**PROPOSED SOCIAL WELFARE FACILITY (RESIDENTIAL CARE HOME FOR THE ELDERLY) IN
“VILLAGE TYPE DEVELOPMENT” ZONE ON APPROVED NAM SANG WAI OUTLINE ZONING
PLAN NO. S/YL-NSW/10 AT LOTS 3670 RP (PART), 3671 RP (PART), 3672 RP (PART) AND 3673
RP (PART) IN D.D.104, NAM SANG WAI, YUEN LONG**

Town Planning Application No. A/YL-NSW/349 - Submission of Further Information (3)

Response-to-Comment Table

Supplementary Traffic Information In
Response to TD's Comments

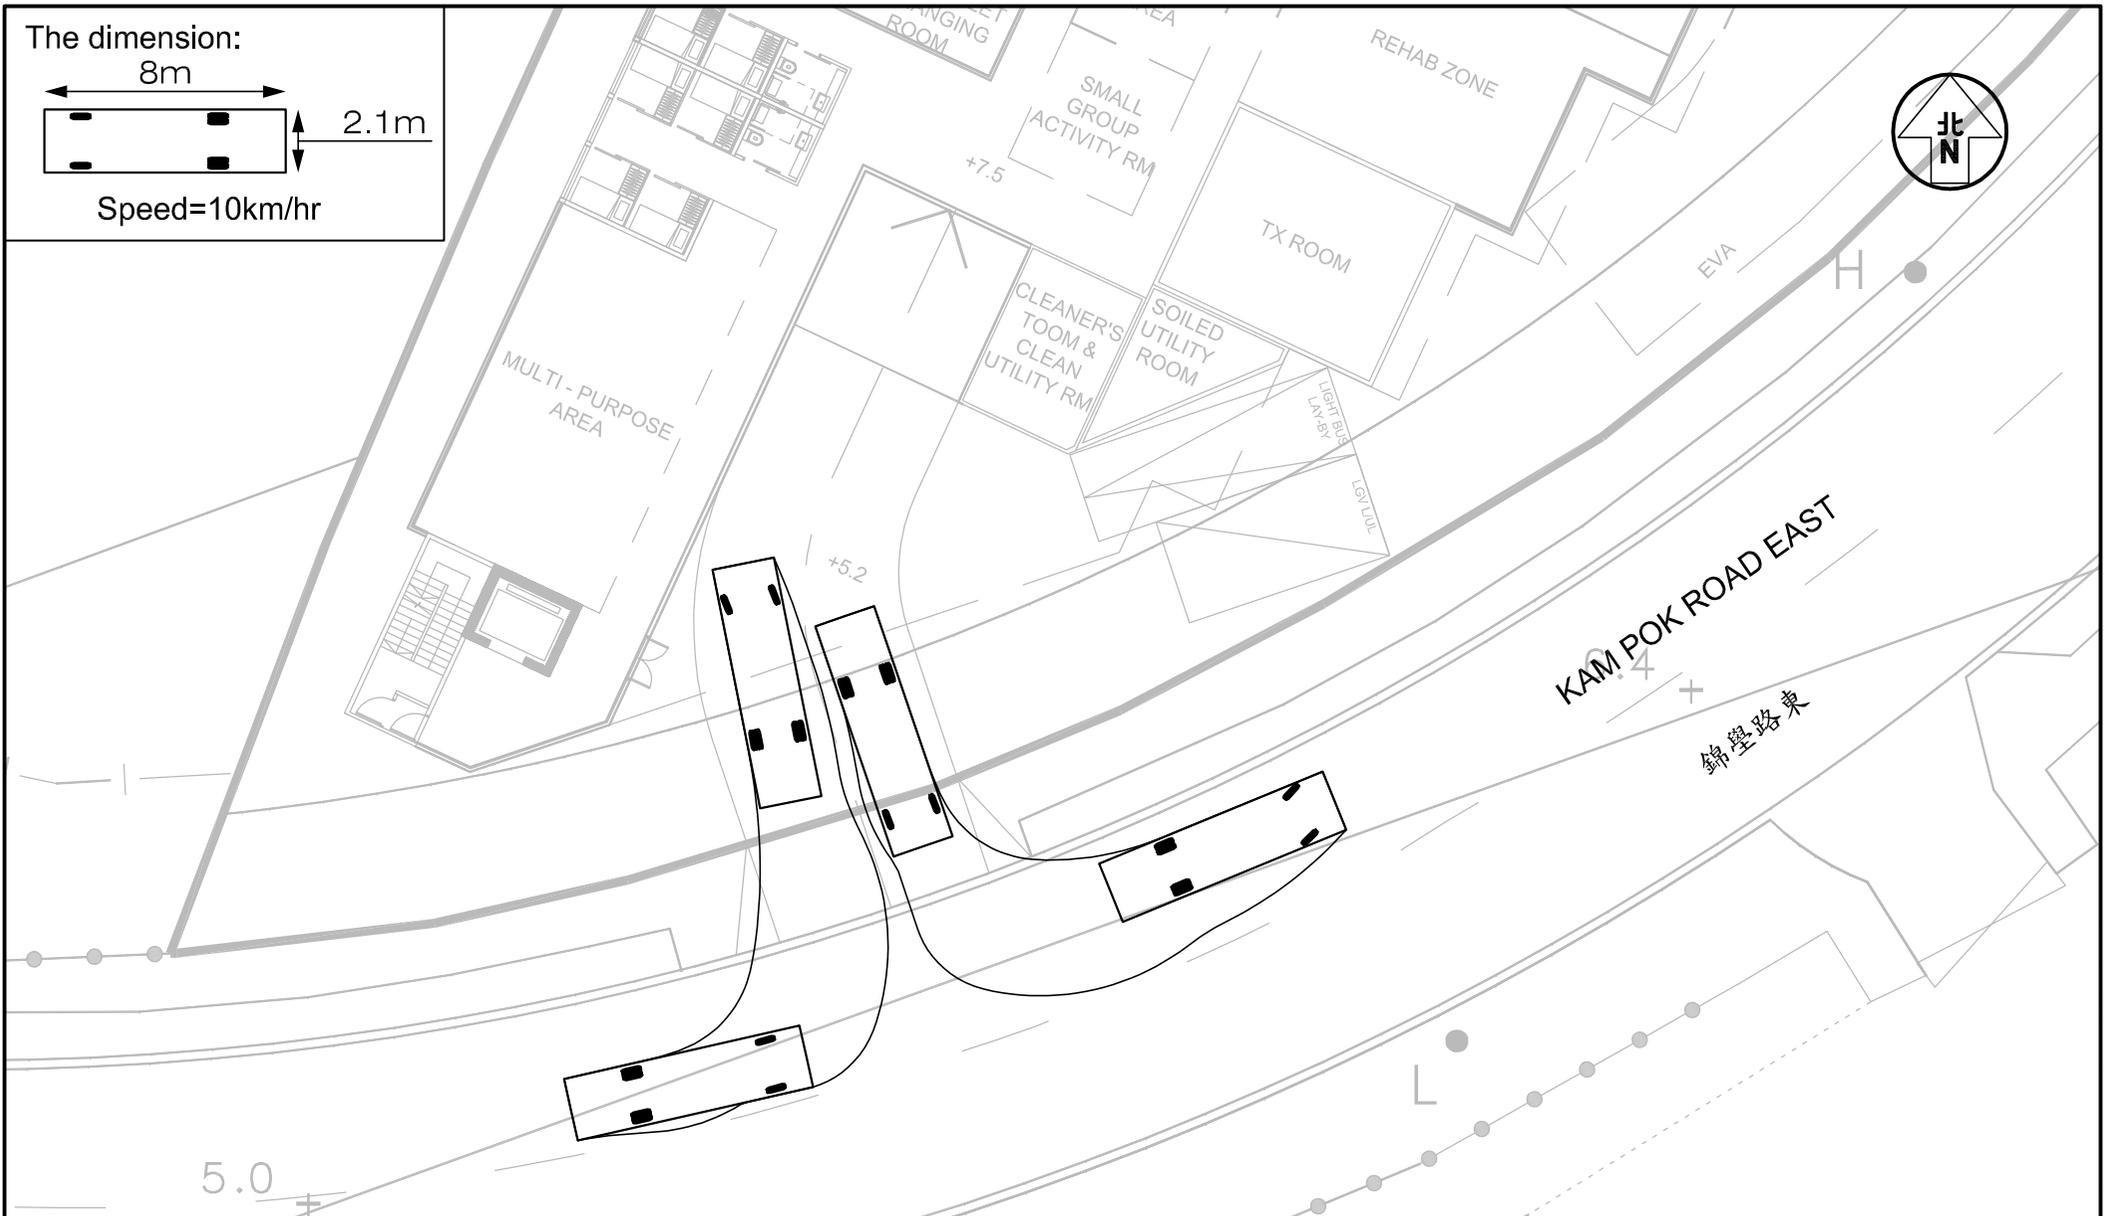
| 7. | Please clearly state the width of the site entrance and provide swept path analysis to demonstrate the width of site entrance could allow vehicle to enter and leave the site simultaneously. | 7.3m-wide run-in/out is provided for the Proposed RCHD to allow vehicle including 8m-long Light Bus to enter and leave simultaneously, please refer to Figure R1 . [See Appendix 5 of the R-to-C table.] |
| 12. | Please provide swept path analysis for the longest vehicle under this application to demonstrate no vehicle would encroach into the opposite lane when leaving the site. | The 8m-long Light Bus which is the longest vehicle expected to enter the Proposed RCHE can leave without encroaching into the opposite lane of Kam Pok Road East. Please refer to Figure R1 . [See Appendix 5 of the R-to-C table.] |
